Section 4.55(1A) Modification Report MOD 3

State Significant Development Application SSD-44034342

Westmead Integrated Mental Health Complex

Submitted to The Department of Planning, Housing and Industry
on behalf of Health Infrastructure NSW

Figure 3 *Modification 3 - Proposed Northern Open Landscape Design*

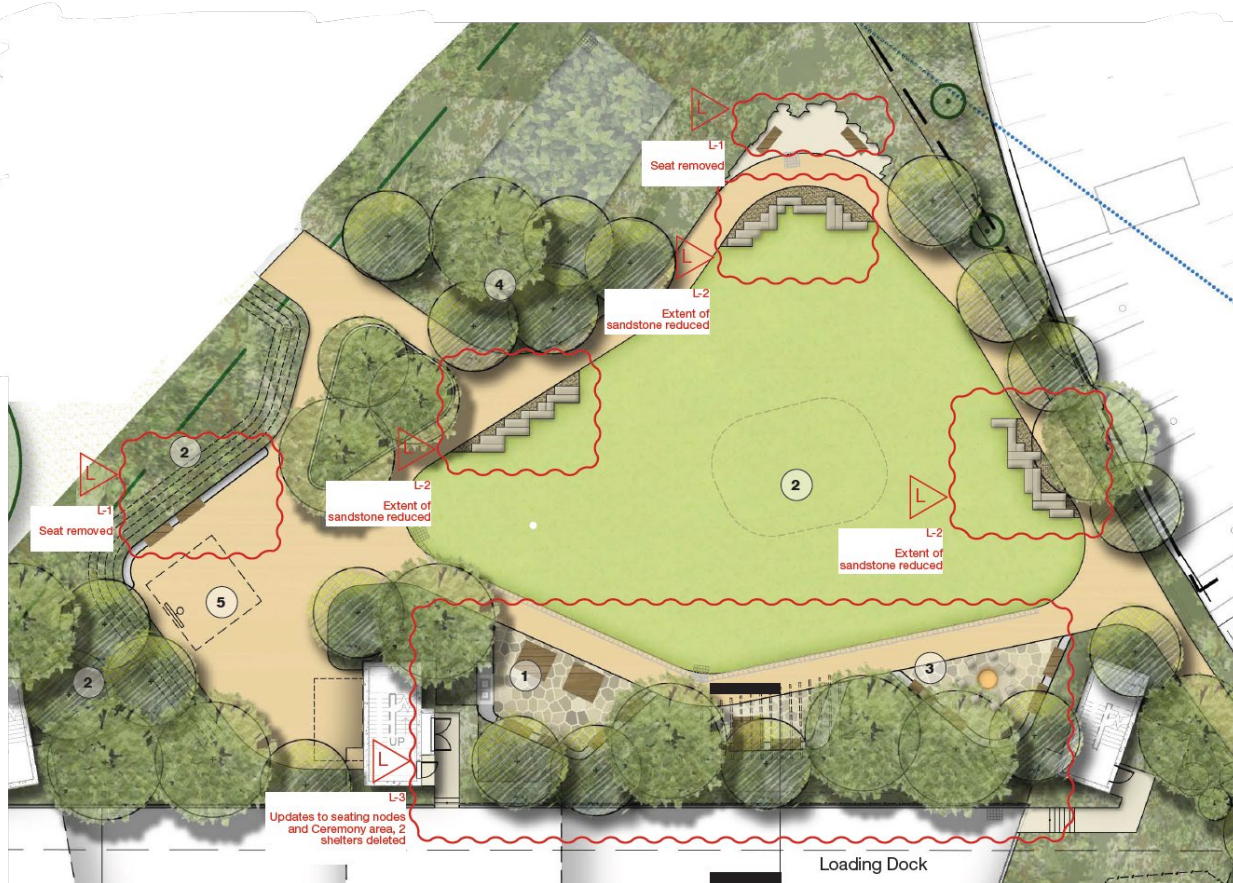
The modifications to the northern open landscaped area comprise the removal of some seating, reduced extent of sandstone, updates to seating nodes and the ceremony area, and the removal of two shelters. The Modification 2 landscape design is shown in **Figure 2** and the proposed modification to the open landscape design is shown in **Figure 3** below.

Figure 4 *Modification 2 – Staff Courtyard Design*

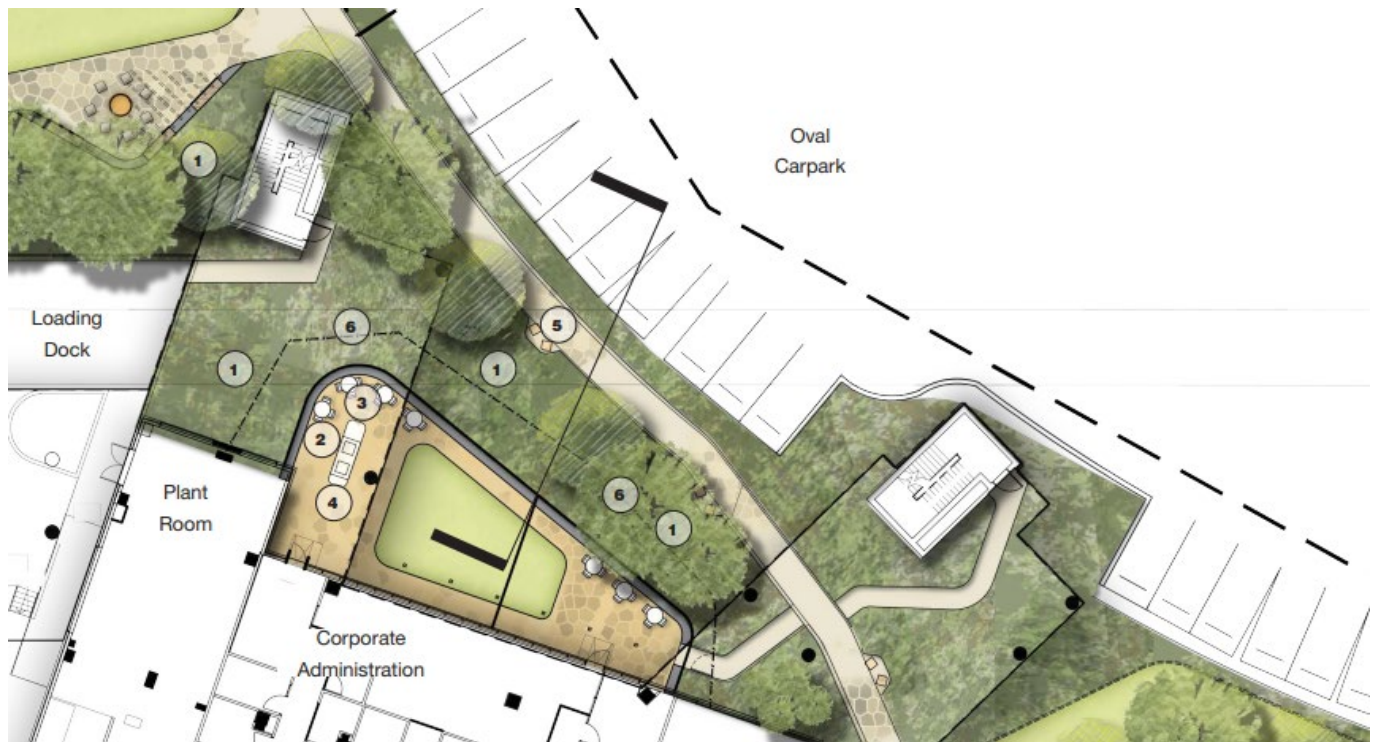
The Staff Courtyard has been modified as detailed in the Landscape Design Report at **Appendix D** and the Landscape Plans at **Appendix C**. The following updates have been made:

- Amended seating wall.
- Addition of a barbeque area.
- Removal of the external pergola.

The Modification 2 design of the staff courtyard and the proposed staff courtyard is shown in **Figure 4** and **Figure 9**.

Figure 7 Modification 3 - Adjustments to the paving at the eastern entry

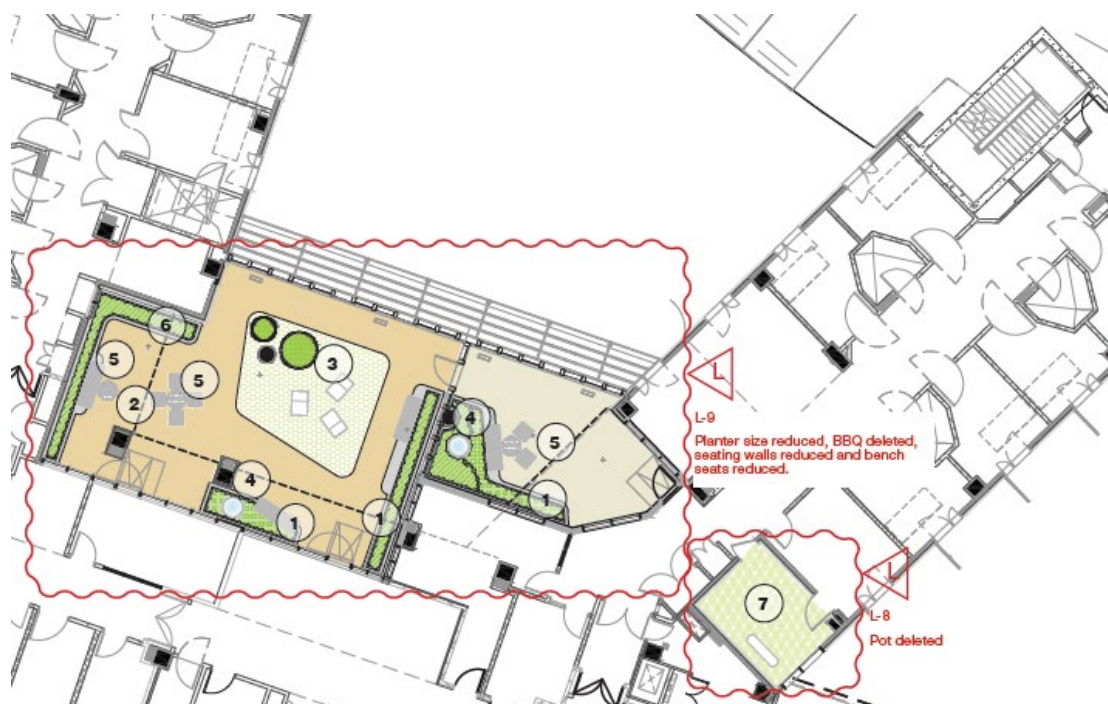
Adjustments have been made to the extent of paving at the site's eastern entry at the bike parking area, as shown in **Figure 7** below. The pavement design proposed under this modification is shown in **Figure 6** below.

Figure 13 Modification 3 - Proposed Non-acute In-Patient A Courtyard

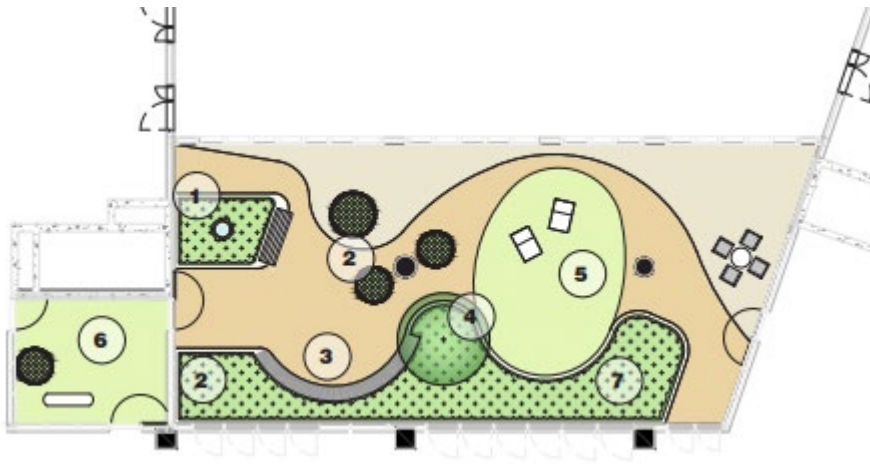
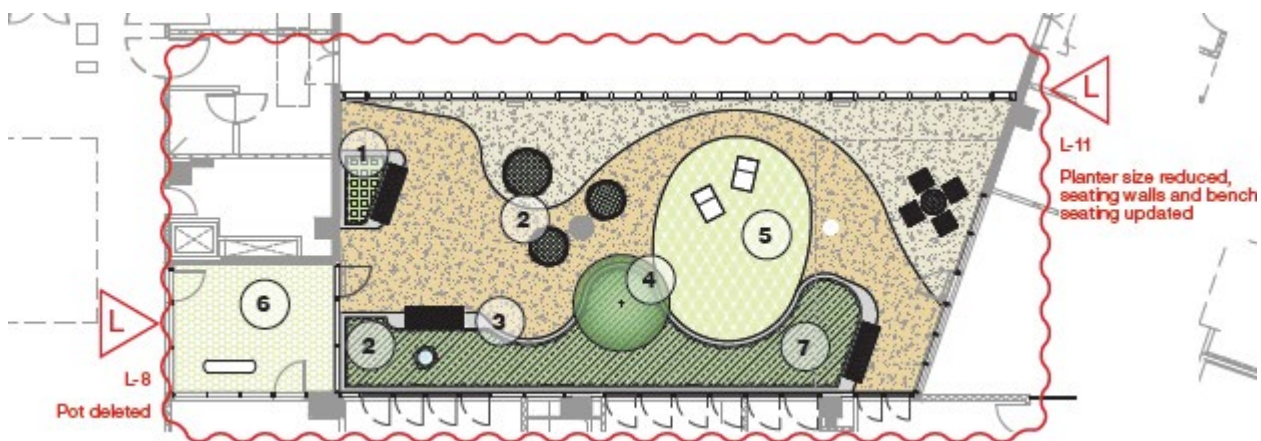
Adjustments to the courtyard landscaping have been made on the eastern and western facades on levels 2 to 9 and have been detailed in the Landscape Plans at **Appendix C** and the Landscape Design Report at **Appendix D**. **Figure 12** illustrates the Non-Acute inpatient A courtyard under Modification 2. **Figure 13** shows the minor updates proposed under this modification. The remaining courtyards, including on levels 2 through 9, are proposed to include similar adjustments, including planting adjustments and layout rationalisation of furniture.

Figure 17 Modification 3 - Alternative brick selected

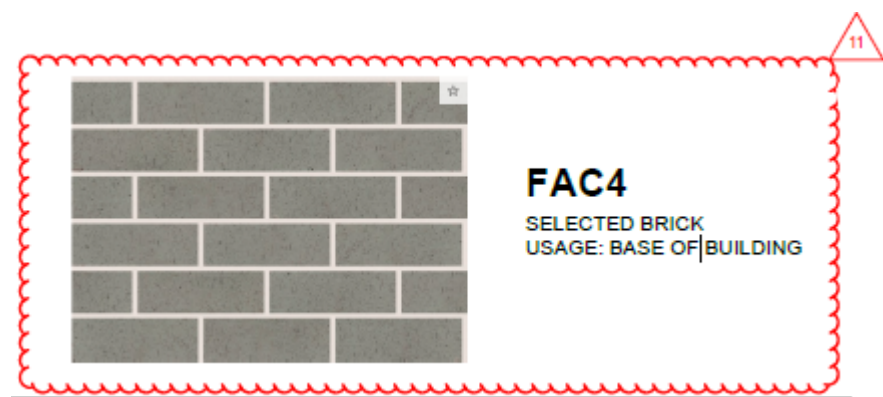
An alternative brick and bond have been selected, replacing the soldier course to stretcher course at the base of the building. The previously selected brick under Modification 2 is shown in **Figure 16**. The proposed brick is shown in **Figure 17**.

The original brick bond was a soldier course (vertical stack), which has now been replaced with a horizontal stretcher course bond. This change has been implemented to enhance buildability by increasing the strength and stability of the walls while also being more cost-effective. The alternative bond type maintains the desired texture and visual interest of the original selection, ensuring that the aesthetic qualities are preserved.

Figure 20 *Modification 3 - Southern Elevation – addition of mechanical louvers labelled as '10'*

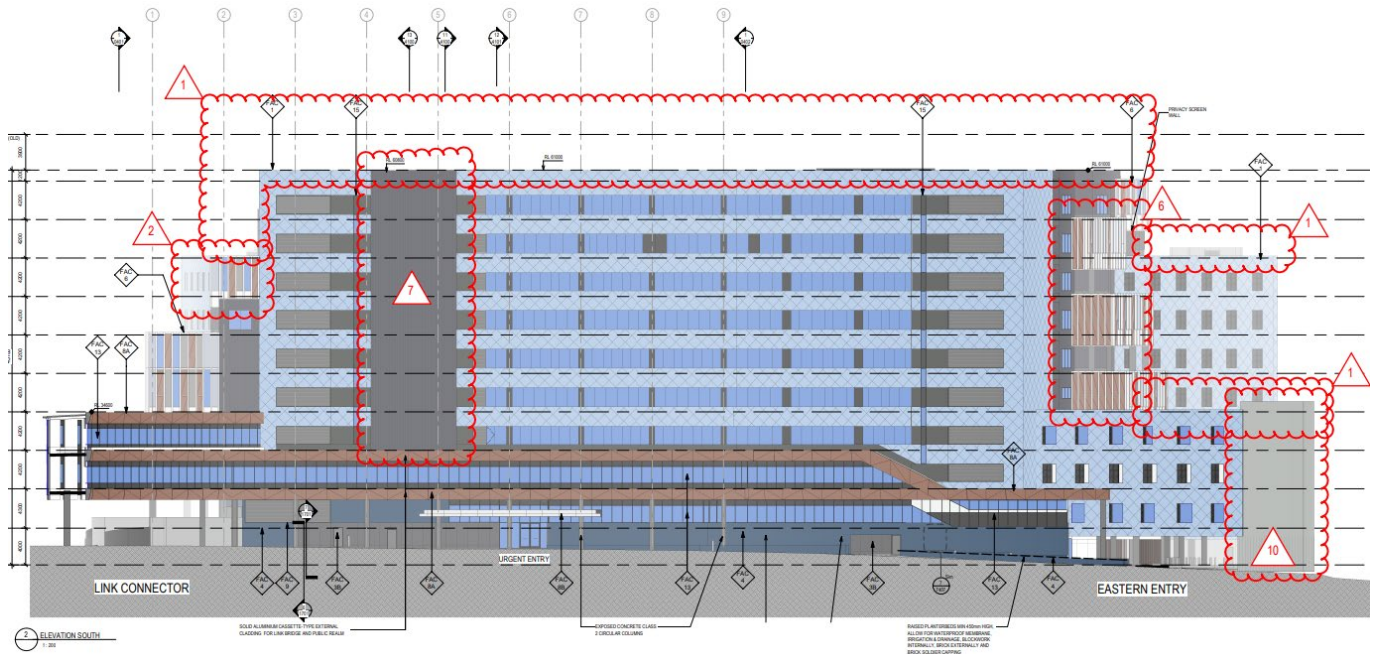
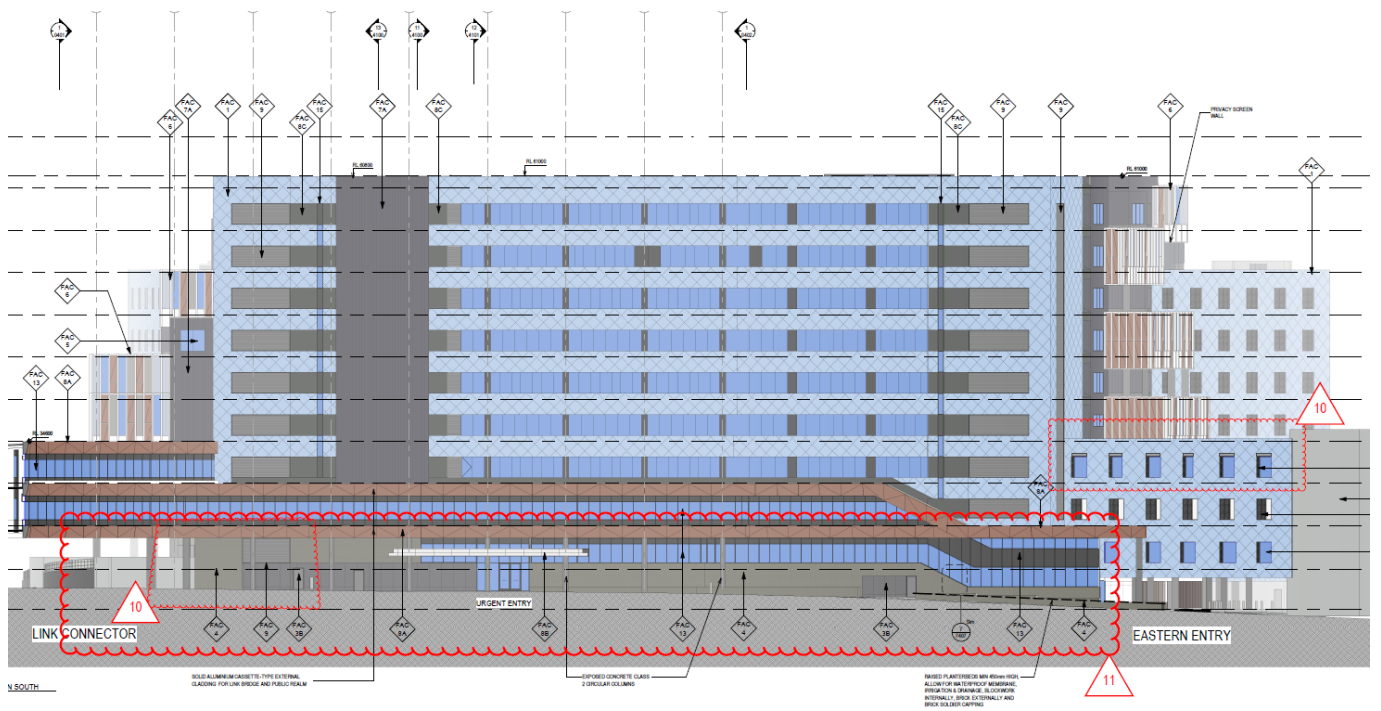
Mechanical louvers have been added to the building façade in various locations as detailed in the Architectural Drawings at **Appendix A**. Excerpts of the proposed mechanical louvers are identified in red outline below which details the additional louvers at each building elevation.

Following on from MOD 1, regarding the On-Floor Plantrooms, the design has progressed in collaboration with the Mechanical Contractor to incorporate the necessary mechanical supply and exhaust louvers for the new plantrooms. The addition of mechanical louvers to the facade is detailed in the Design Statement prepared by Jacobs at **Appendix B**. This includes adding periphery louvers to accommodate the air conditioning systems and adjusting the sizes of the existing plant room louvers to meet the updated requirements. The plant selections are being finalised as part of the Design Finalisation process.

The need for these changes arises from the ongoing development and finalisation of the building’s services plant and equipment, which has necessitated the inclusion of additional louvers and adjustment to the existing louvers’ sizes and locations.

The new louvers have been carefully positioned to minimise any impact on the building’s overall aesthetics and are coloured to match the surrounding cladding, ensuring they blend seamlessly with the building’s exterior.
